# SERVICE BULLETIN

from: TRIO-KENWOOD COMMUNICATIONS, INC.

TR-7625

SUBJECT: TR-7625 HYBRID AMPLIFIER MODULE SUBSTITUTION

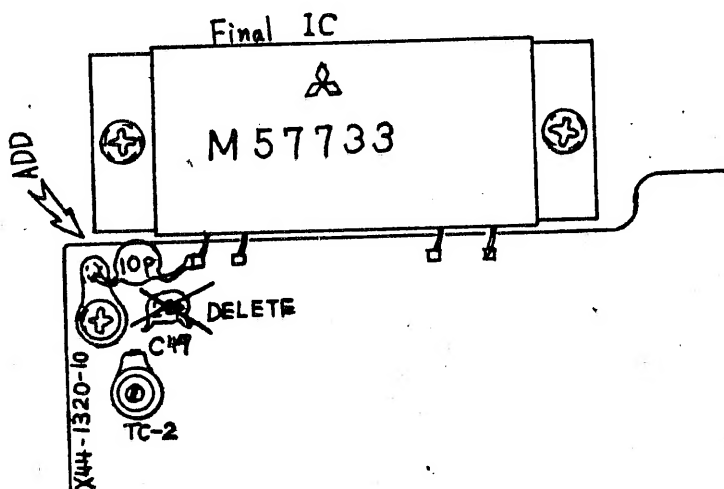
Final modules obtained from Trio-Kenwood Communications's Parts Department after 6/1/80 MUST be installed as outlined. Two versions of the hybrid may be supplied, either marked as an M57712H, or as an M57733. This information applies in either case.

1. Remove and delete C49, 22pF.
2. Add a ground lug adjacent to the RFI terminal.
3. Add 10pF across the RFI terminal and ground.

1. Adjust TC2 for maximum output at 146MHz.
2. Adjust VR4 for 5W output at 146MHz, low power.
